Lots Road Power Station And Chelsea Creek

Planning Permission Ref. PP/02/01324 – Submission of Details Pursuant to Condition 6

Condition 6 – Vehicular Access

RBK&C TRANSPORTATION COMMENTS

9m Rigid Vehicle
Entry/Exit Swept Path Analysis
Approach from West

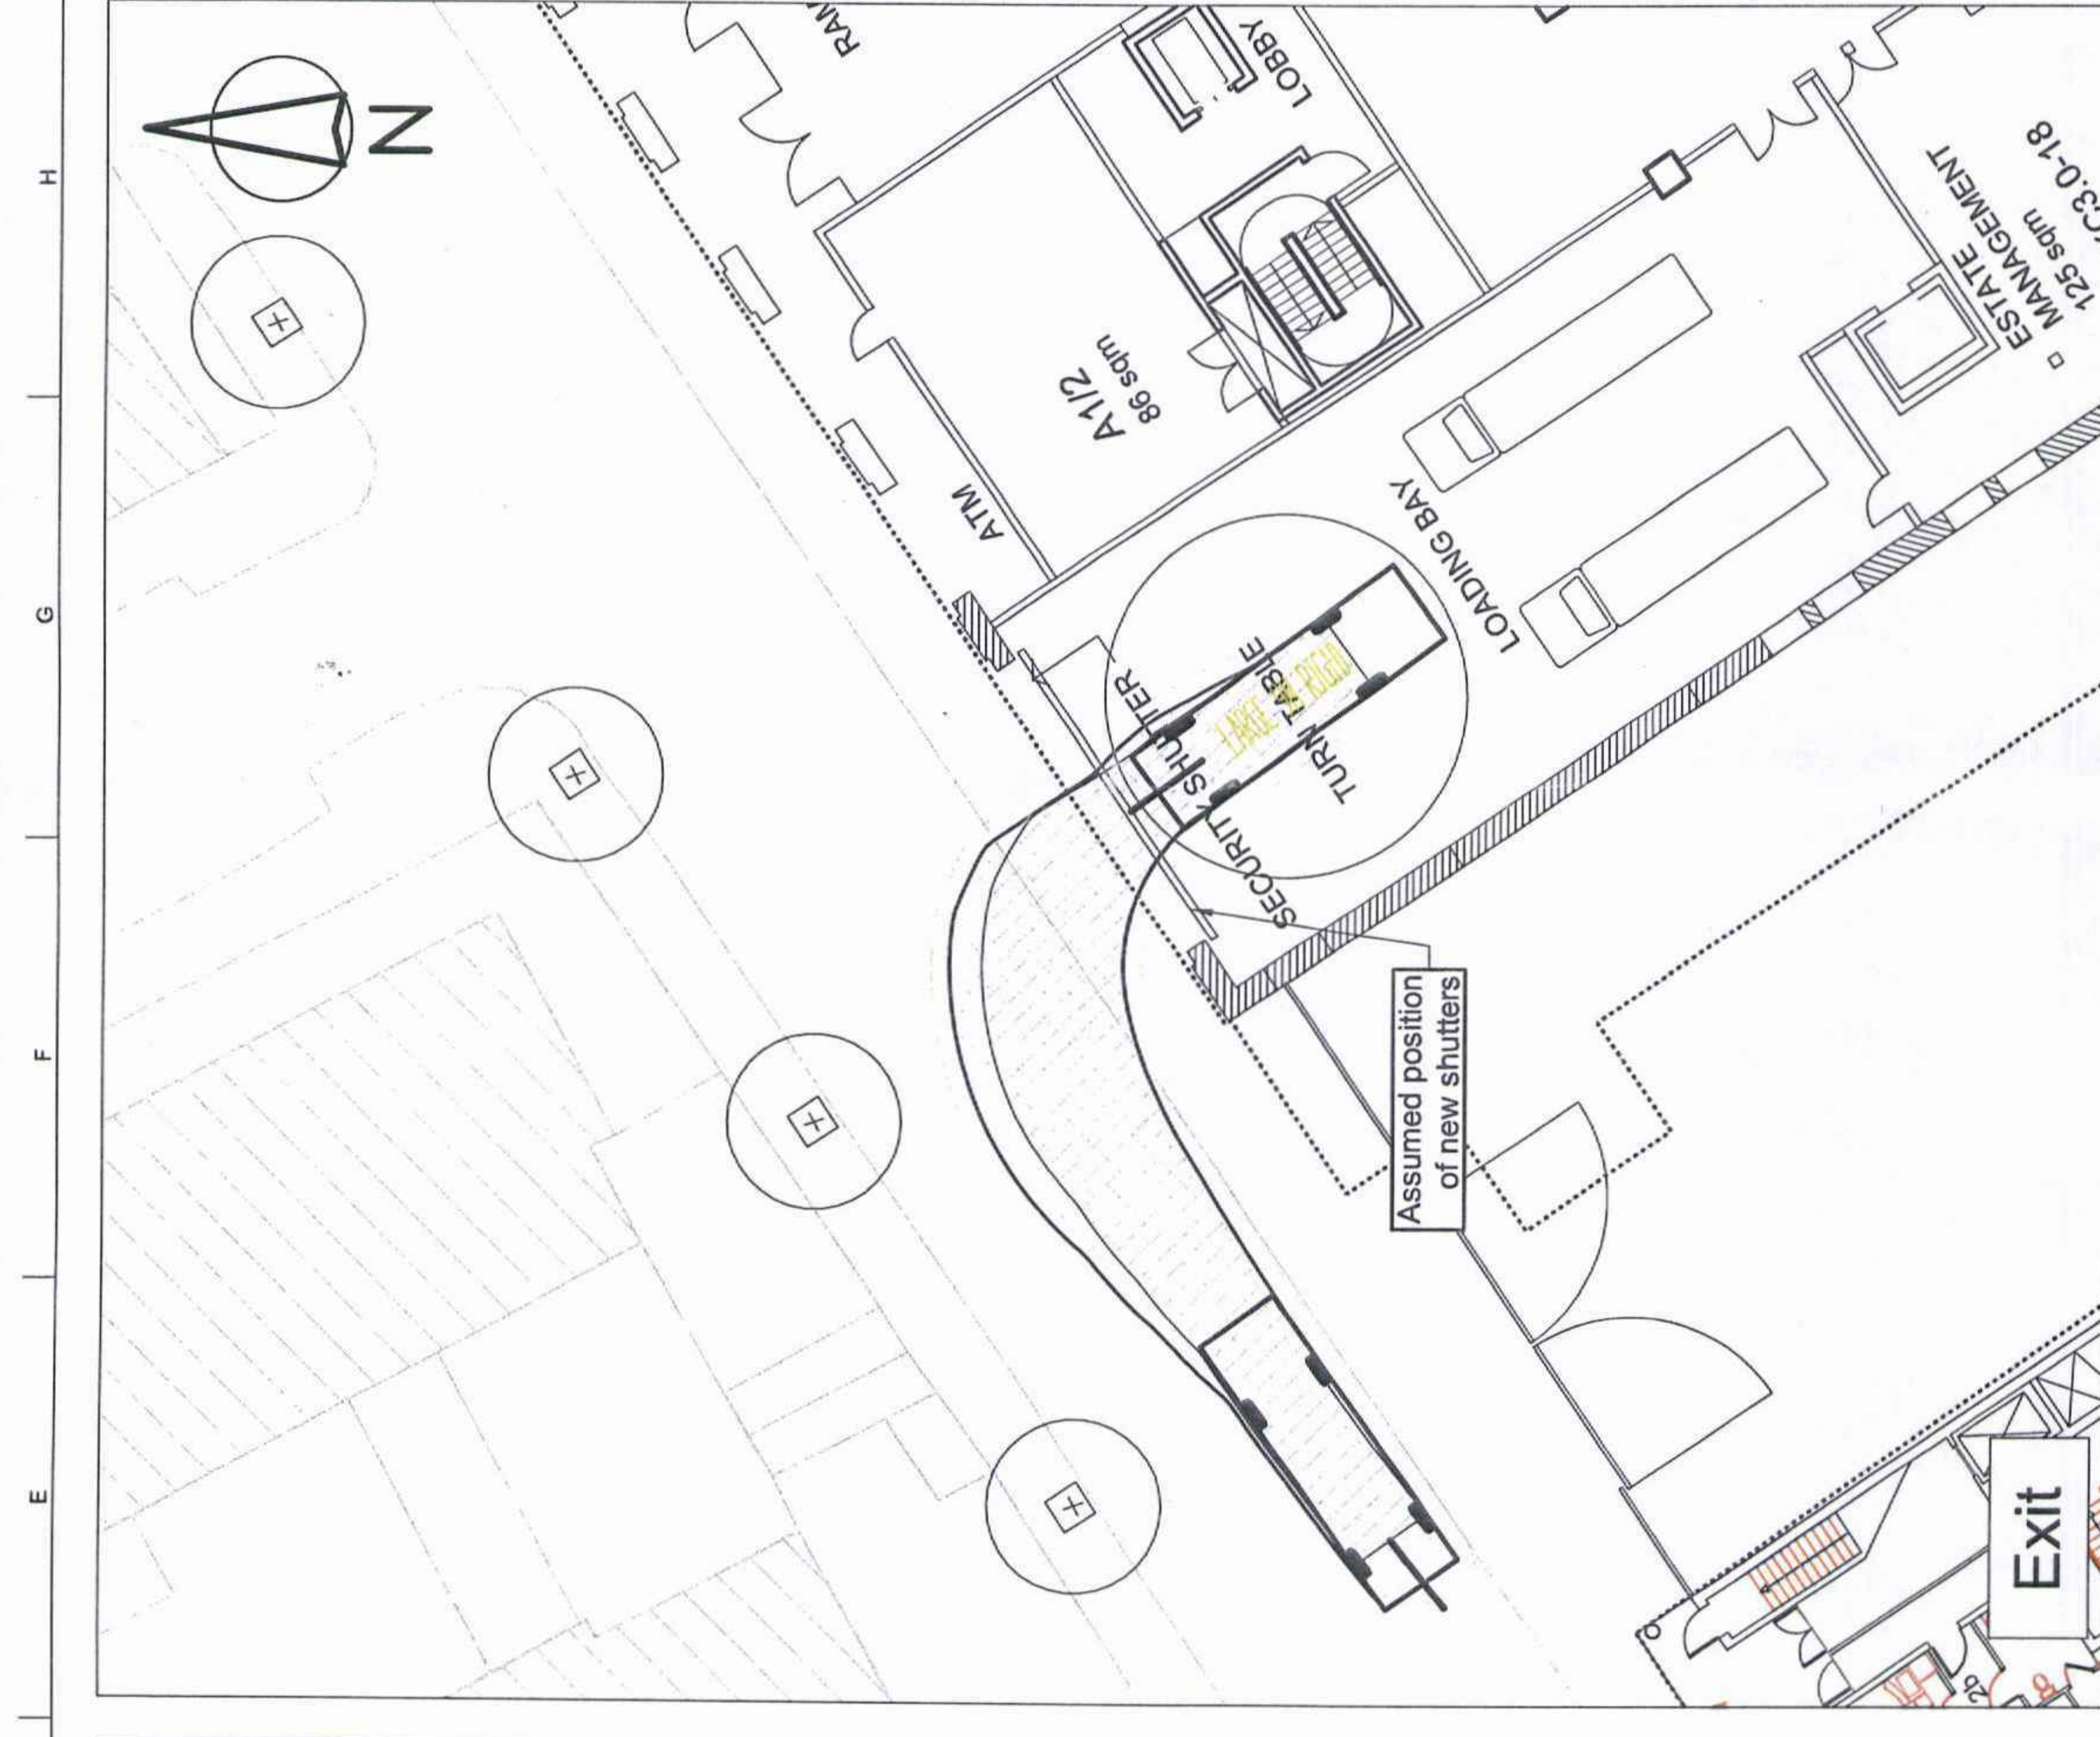
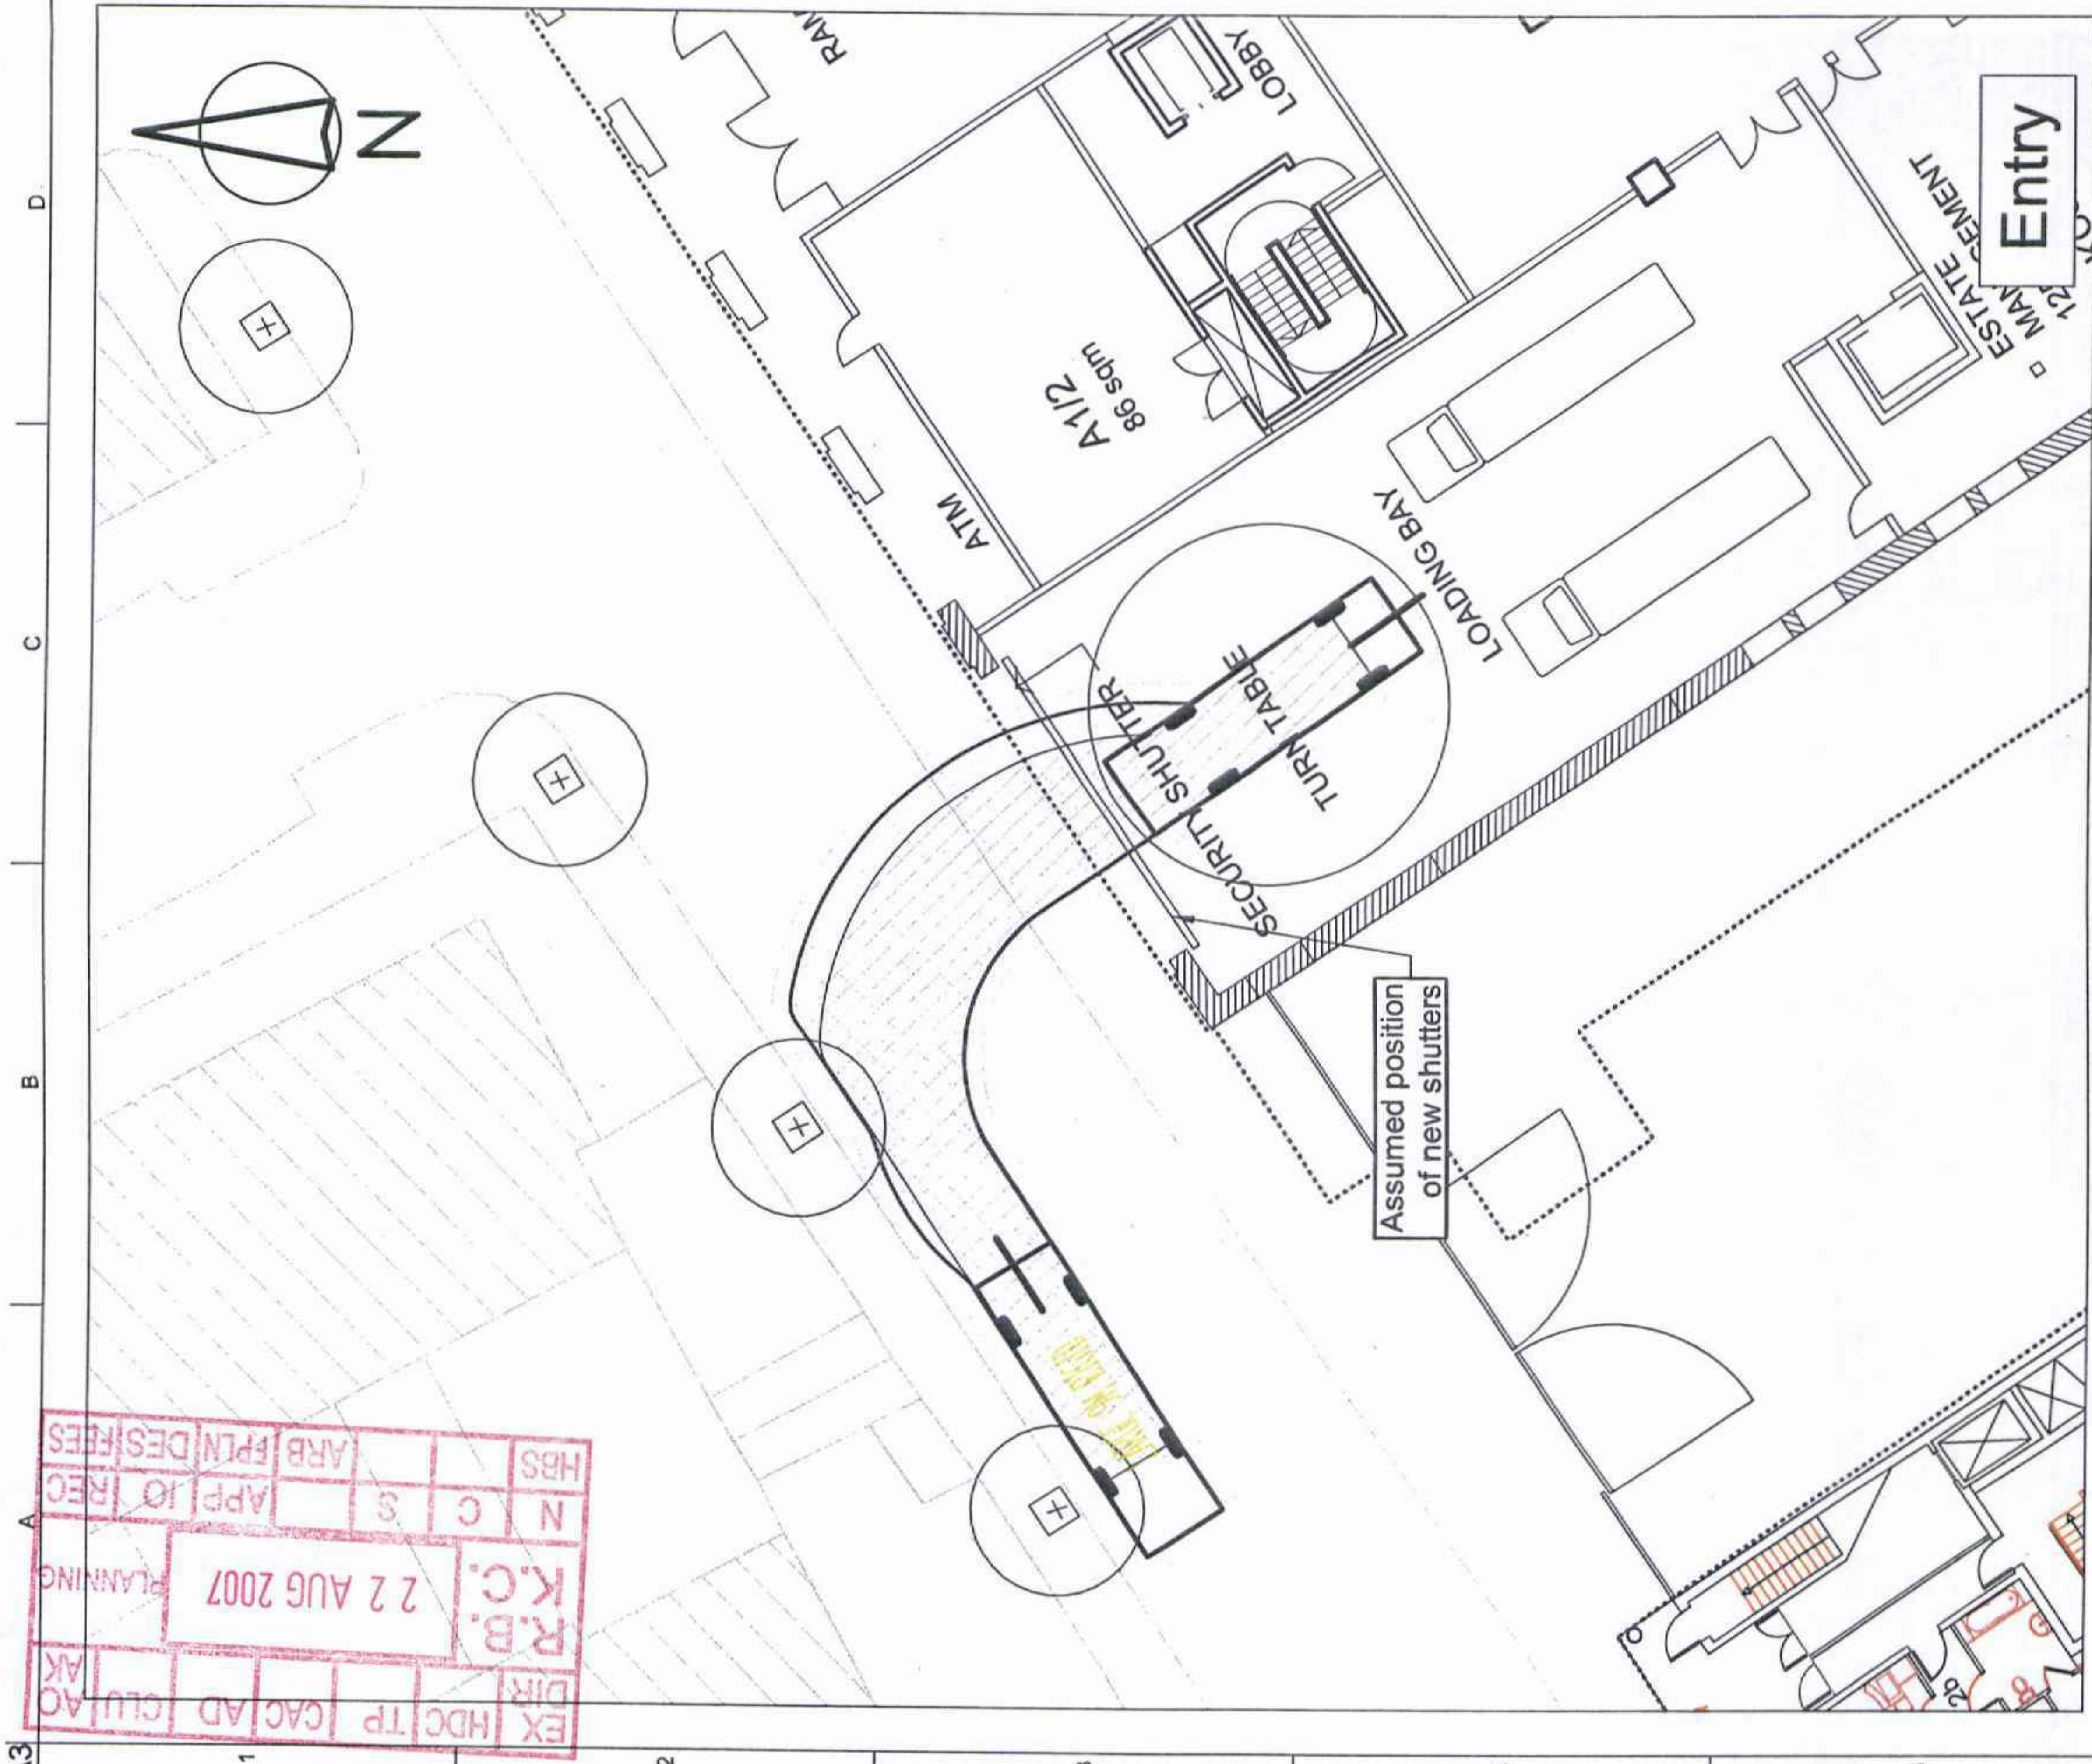
The access to the loading bay at the western end by KC3.0-1 indicates that on street parking on both sides of Lots Road will need to be permanently removed. Drawing nos 123162-02-48 & 49 show the swept paths of a 9m rigid vehicle on entry and exit for both directions. On a point of detail the 'approved' ground level drawing shows two security shutters with a column between them whereas the drawings showing the swept paths only shows one large shutter. This should be resolved.

The access to the loading bay at the western end by KC3.0-1 indicates that on street parking on both sides of Lots Road will need to be permanently removed. Drawing nos 123162-02-48 & 49 show the swept paths of a 9m rigid vehicle on entry and exit for both directions. On a point of detail the 'approved' ground level drawing shows two security shutters with a column between them whereas the drawings showing the swept paths only shows one large shutter. This should be resolved.

- 2) The entire West Yard and the Bulk Supply Building is owned by LUL and given the status of the building there are restrictions on the use of the West Yard and no access is permitted. We can therefore confirm that as per the planning permission, all access to Block KC4 will be from Lots Road. We confirm that there is no access from the rear of Block KC4, in line with the consented drawings. The crossover is to remain as existing and the current restrictions on the use of the yard by LUL prevail. Please refer to Arup drawing 123162-03-39A.

- 3) We can confirm that one opening with no central "pillar" (ie shutter) will be required. Two shutters within the existing arrangements will restrict the size of vehicles to van type and smaller with a consequent adverse impact to on-street parking.

Although the turntable will be designed to accommodate 10m rigid vehicles, access to the service area should be restricted to 9m rigid vehicles for ease of operation.
